DISTRIBUTION CODE MODIFICATION PROPOSAL FORM

Modification Proposal submitted By: Tony Hearne	DATE OF SUBMISSION OF PROPOSAL: 9 th April 2013	Modification Proposal Number: <i>(to be assigned by Review Panel Secretary)</i> #22
CONTACT DETAILS FOR MODIFICATION PROPOSAL ORIGINATOR: (IF NOT DISTRIBUTION CODE REVIEW PANEL		
NAME: Tony Hearne	TELEPHONE NUMBER: 01 7026276	
E-MAIL ADDRESS:	tony.hearne@esb.ie	
MODIFICATION PROPOSAL TITLE:	DS3 Fault Ride-Through	
DISTRIBUTION CODE SECTION(S) AFFECTED BY PROPOSAL DCC11.2.1		
MODIFICATION PROPOSAL DESCRIPTION <i>(Clearly state the desired amendment and all text changes. Attach further information if necessary)</i> <ol style="list-style-type: none">1. Replace the current content of DCC11.2.1 with the material shown in Appendix 12. Add the new definitions shown in Appendix 2		
MODIFICATION PROPOSAL JUSTIFICATION <i>(Clearly state the reason for the modification. Attach further information if necessary)</i> Active and Reactive Power responses for the WFPS are to be re-defined to offer a more rapid response from WFPS during and after a system event.

Appendix 1: Distribution Code body content

Figure 9: Fault Ride-Through Capability for Controllable Wind Farm Power Stations connected to the Distribution System.

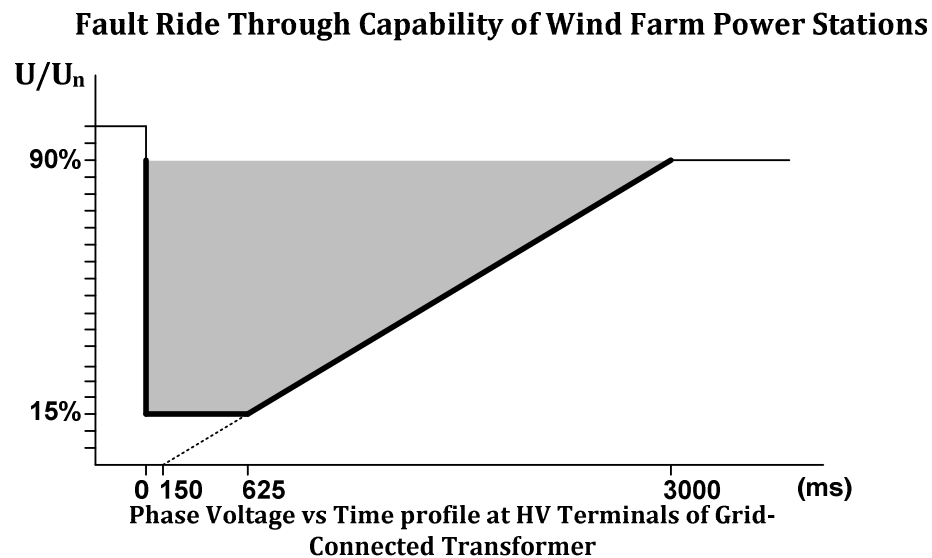
DCC11.2.1 A **Controllable WFPS with Registered Capacity >5MW**, shall remain connected to the **Distribution System** for **Voltage Dips** on any or all phases, **and shall remain Stable**, where the Distribution System Phase to phase Voltage measured at the **Connection Point** remains above the heavy black line in *Figure 9*.
